Lot 1070 - Anderson Creek Academy

PROJECT TITLE:
The Winston LH

PROJECT NO: 15069AL

SHEET TITLE:
TITLE SHEET

1st Floor Plan 'Coastal'

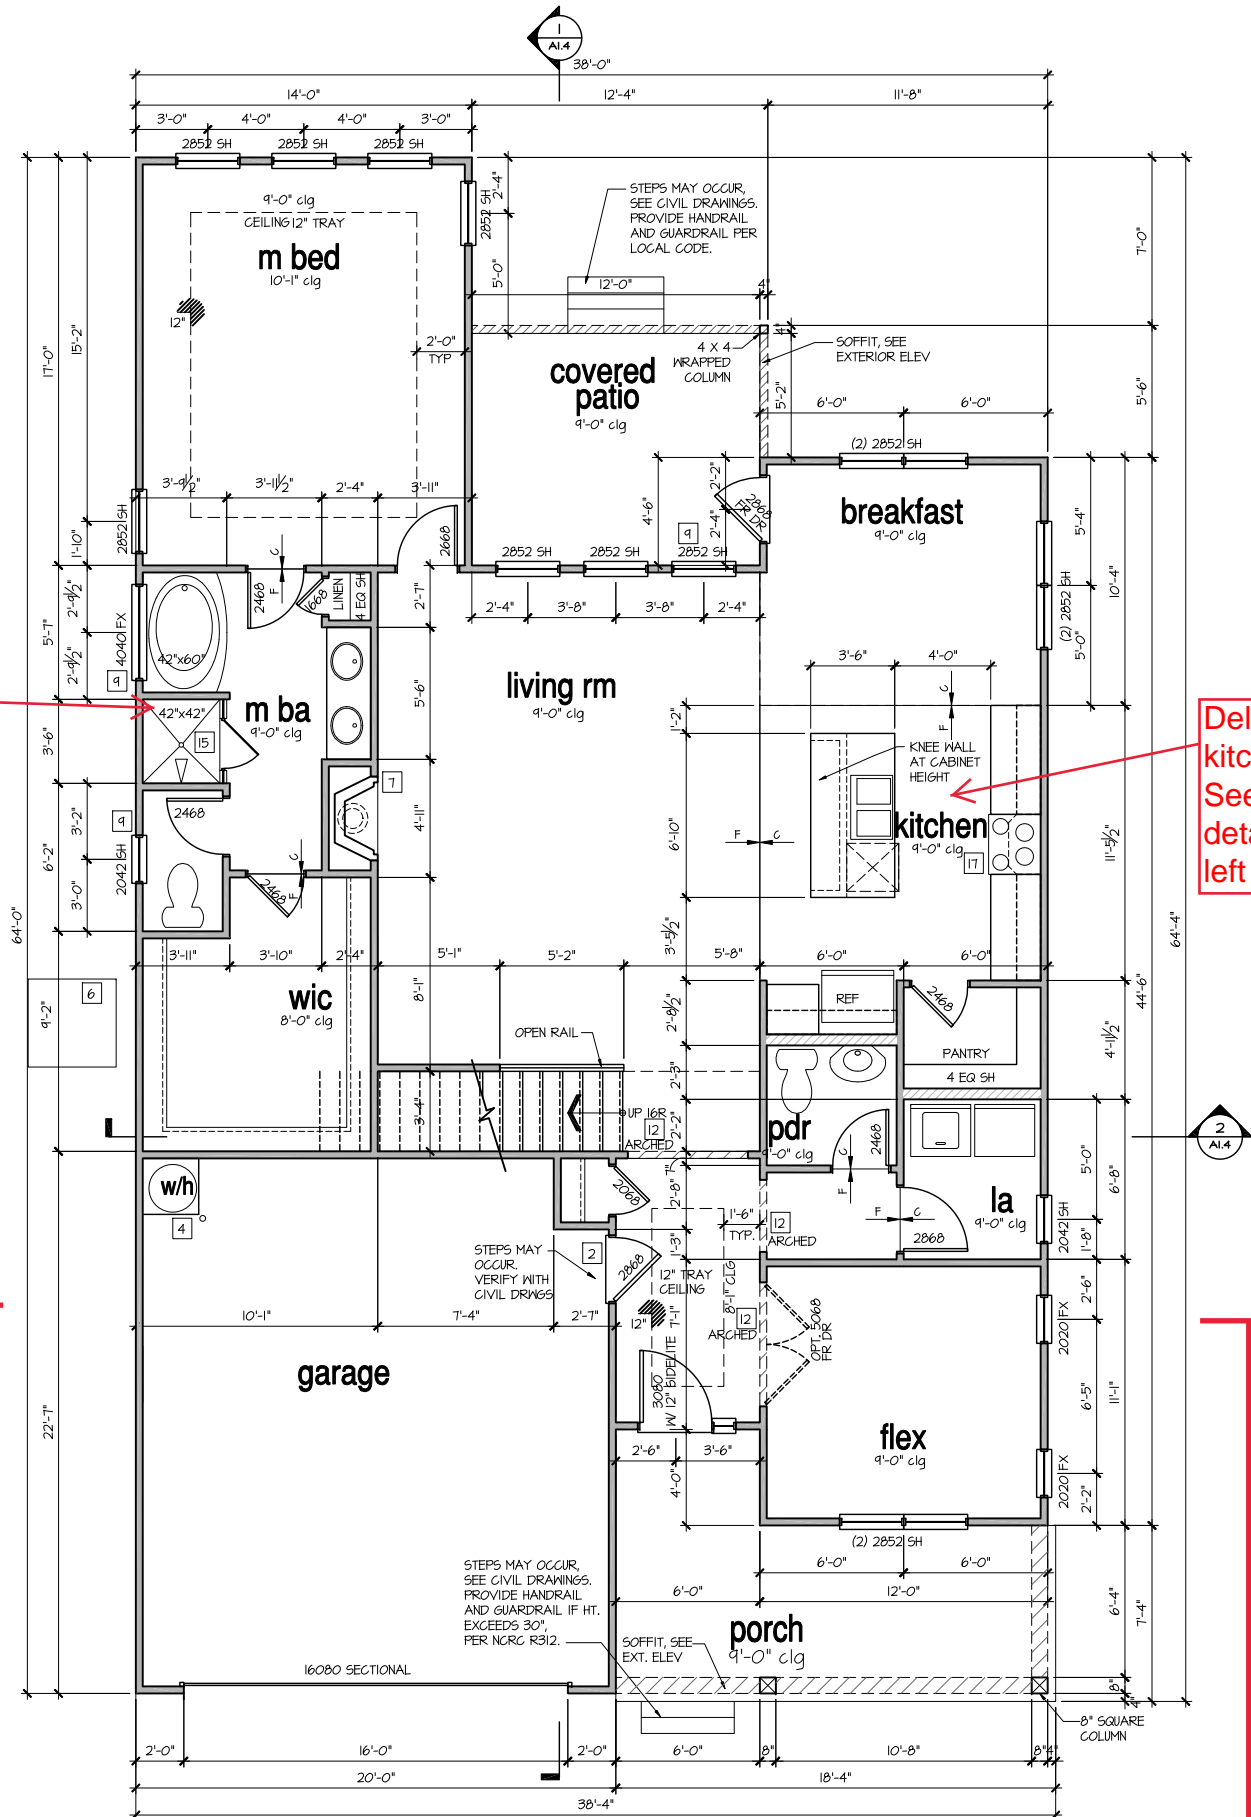
Tile shower - half wall w/ glass panel return

Deluxe kitchen See detail to left

Euro See next pg

Opt. Deluxe Kitchen

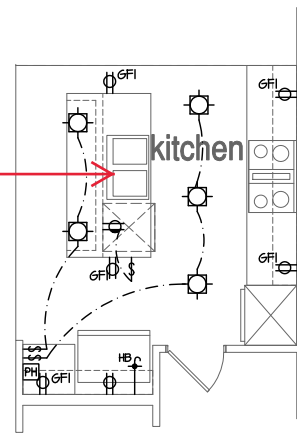
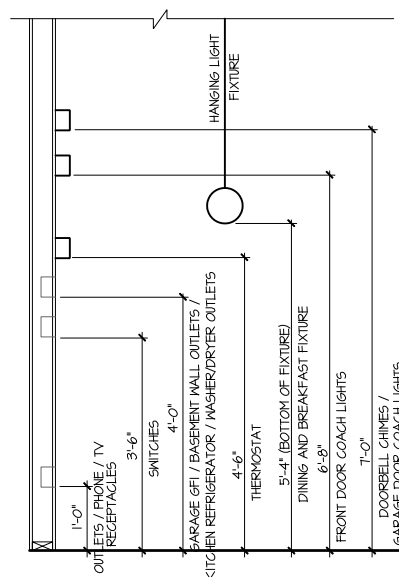
Add coastal pendant centered over island

FOUNDATION PLAN
CRAWLSPACE OPTION
~~COASTAL ELEVATION~~

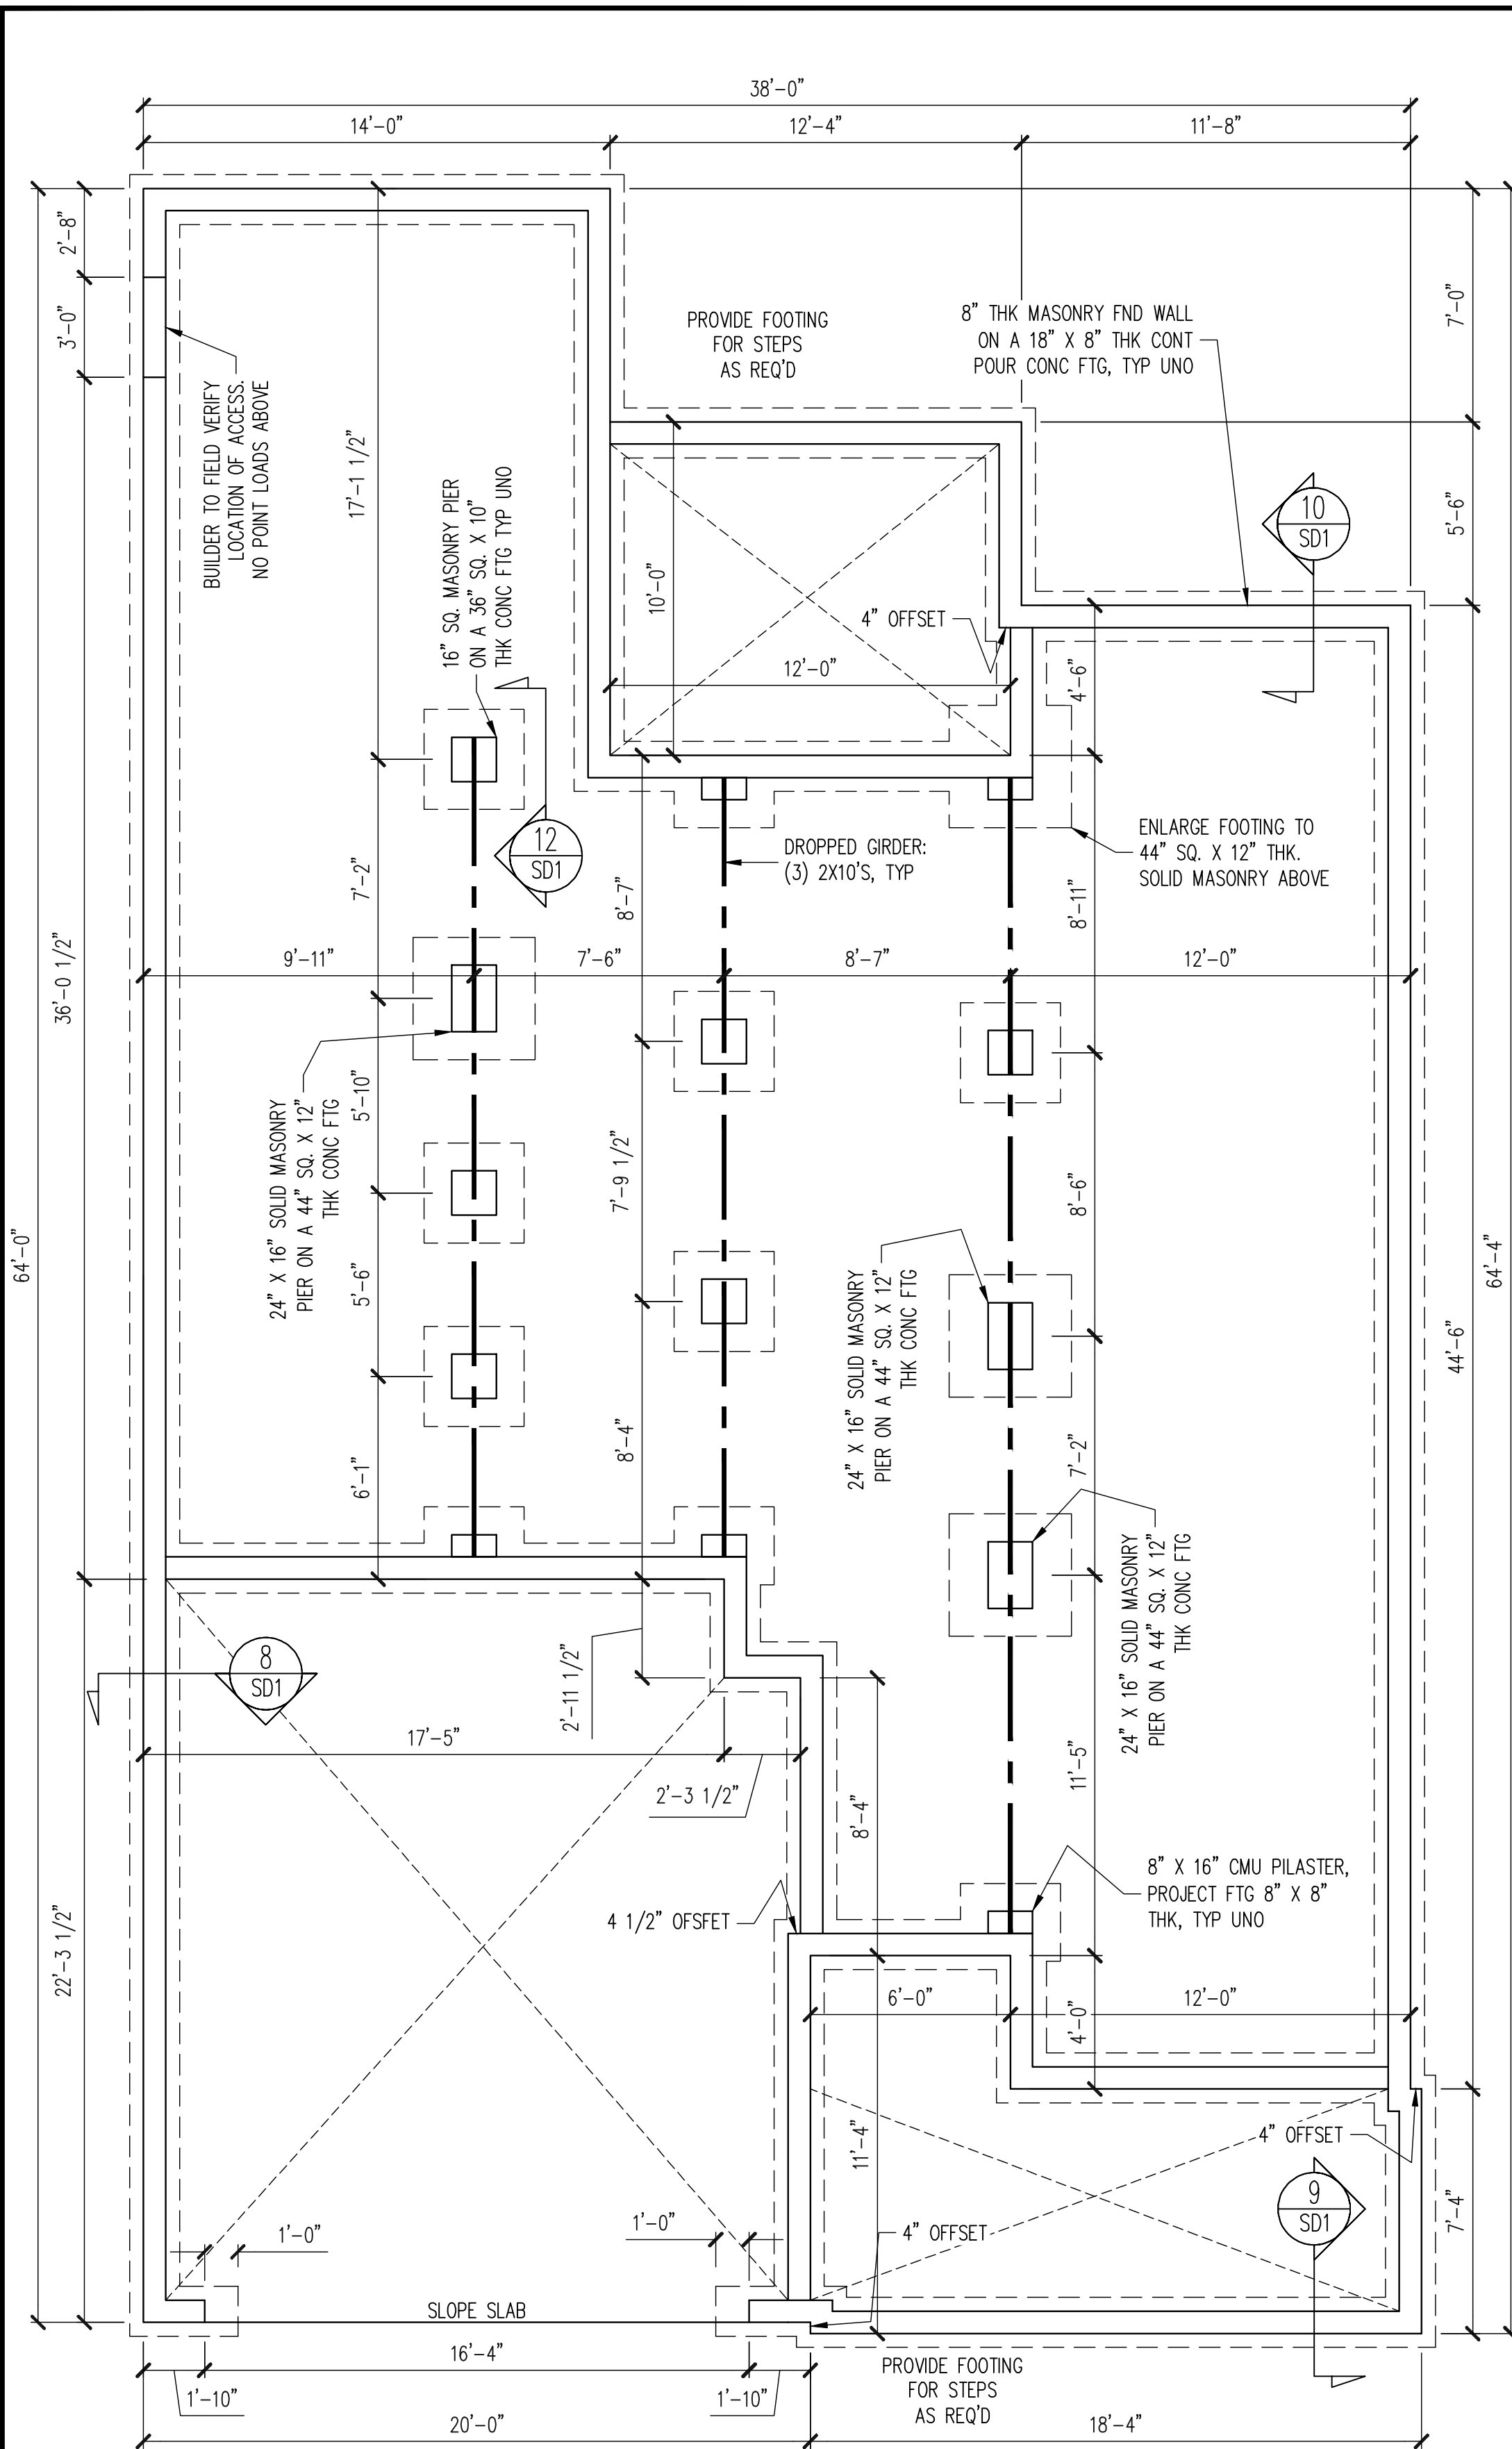
Euro
See pg S8

CRAWL SPACE FRAMING PLAN
~~COASTAL ELEVATION~~

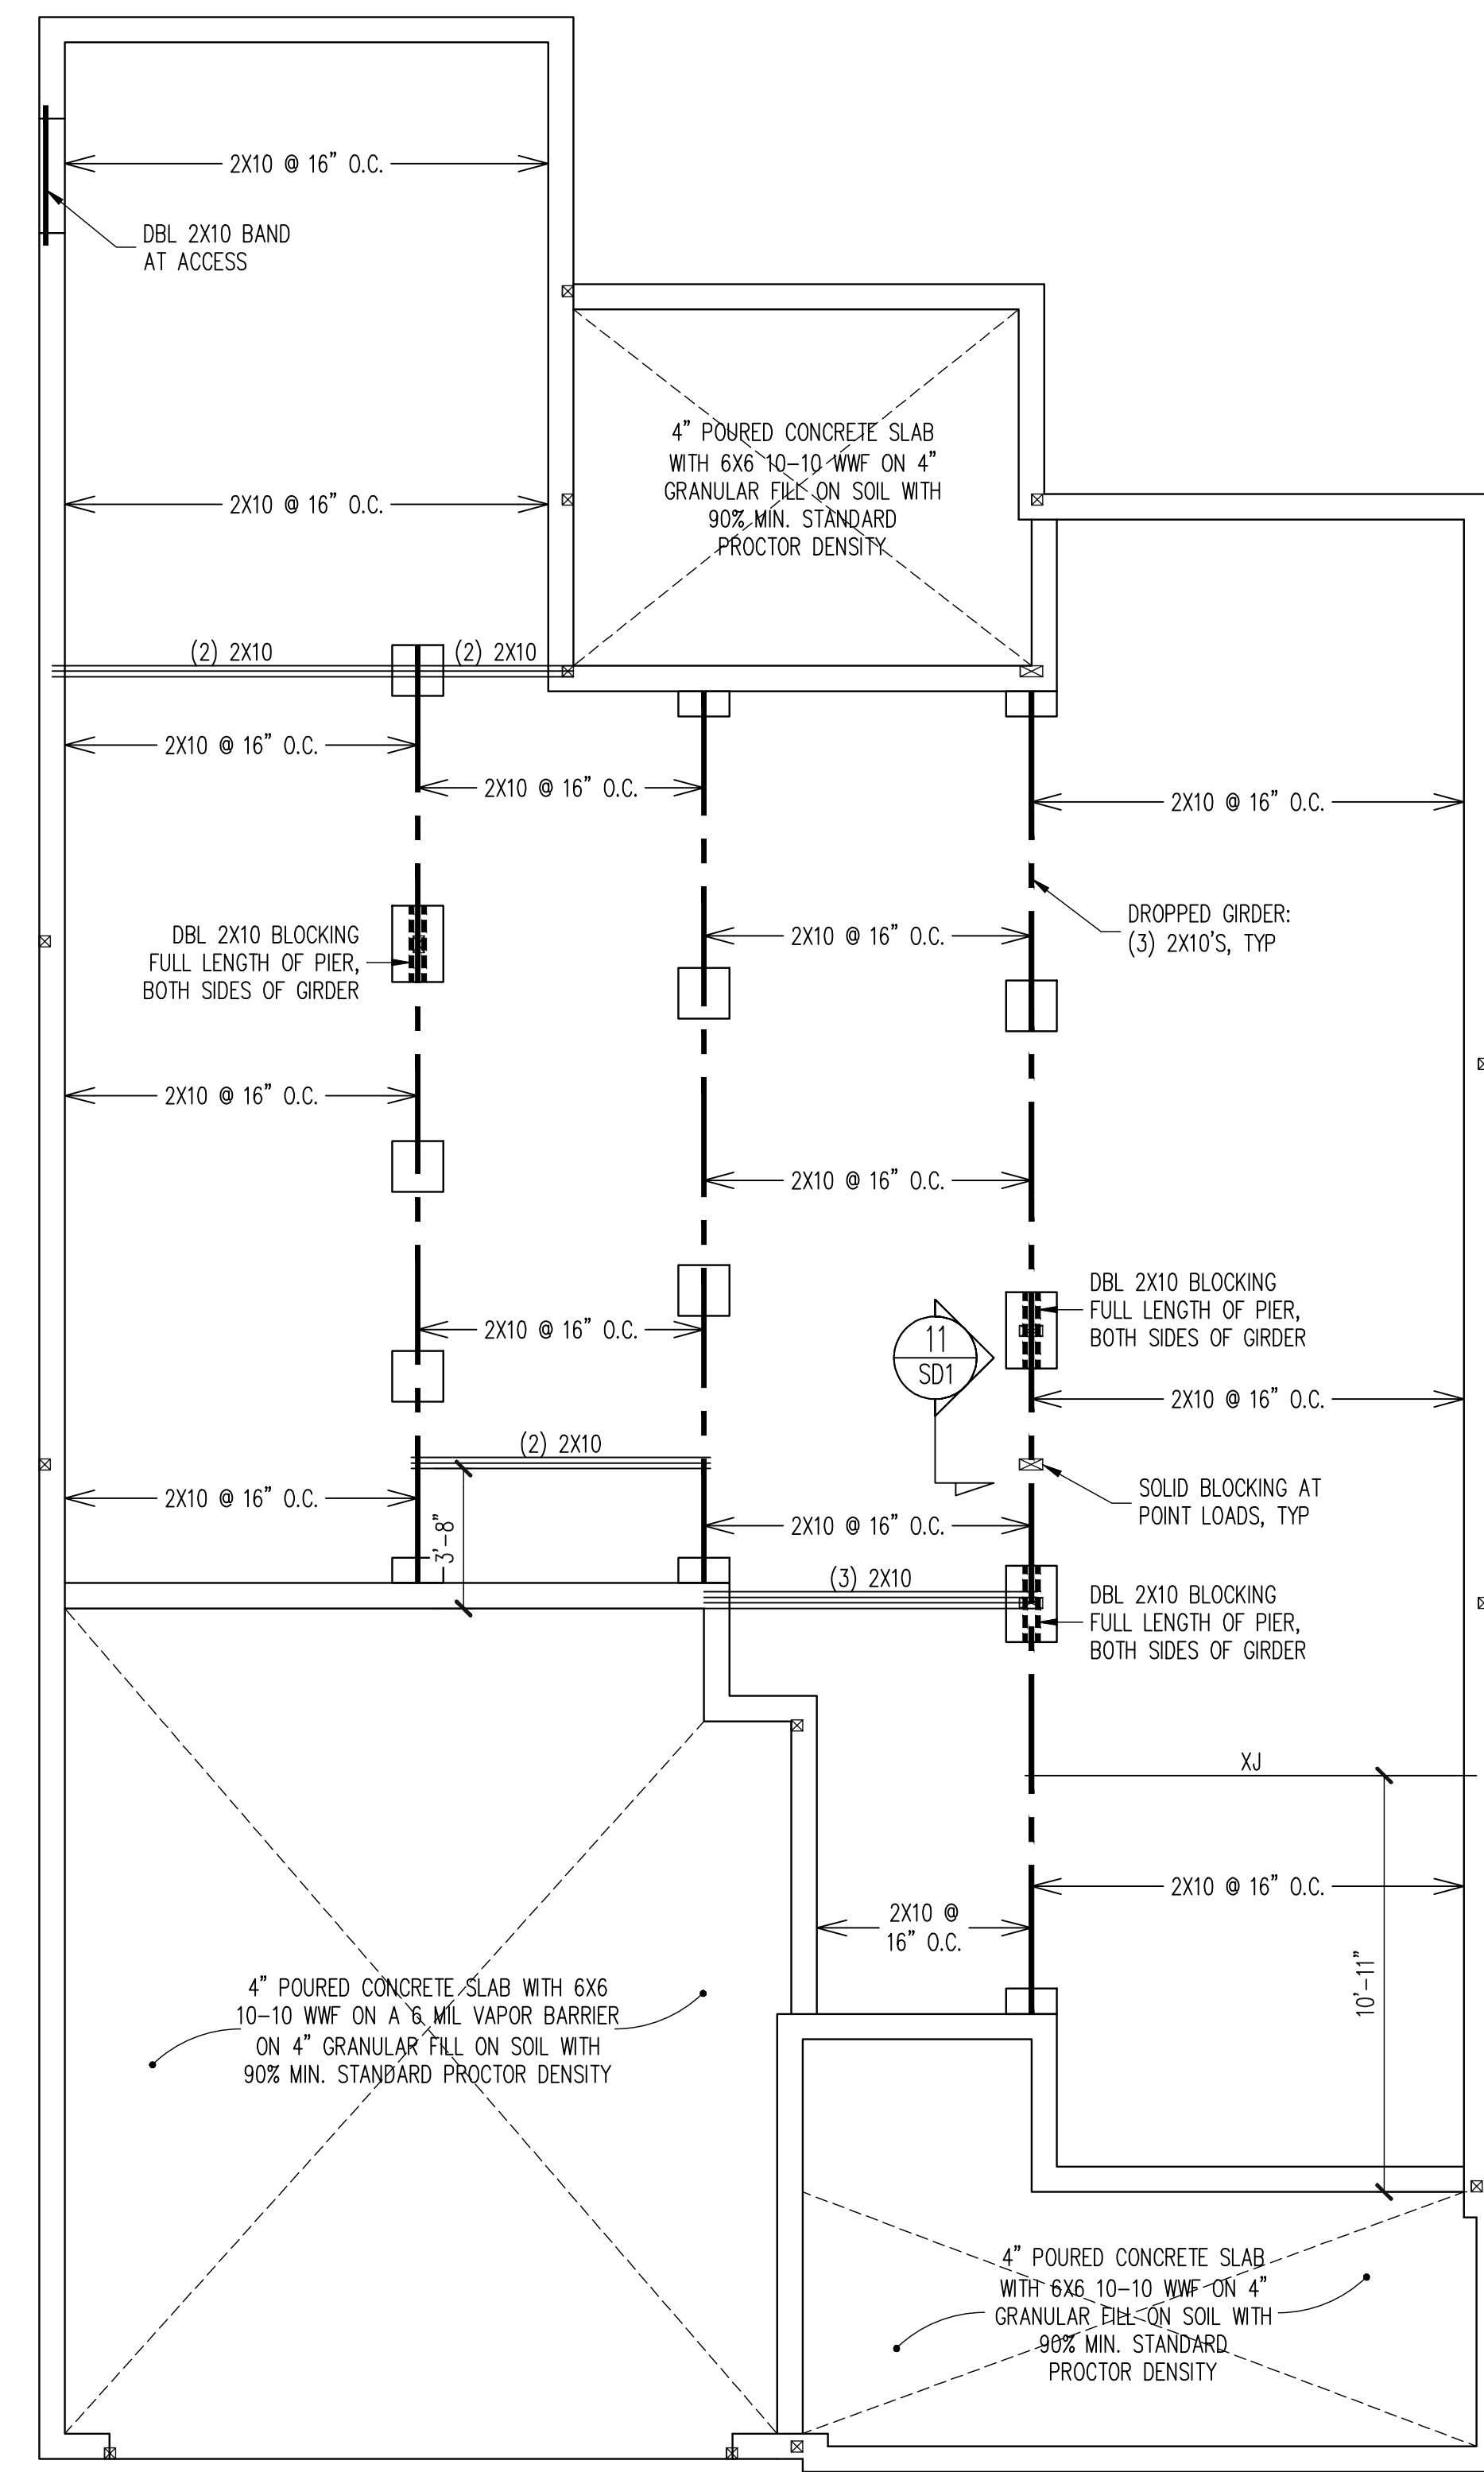
Euro
See pg S8
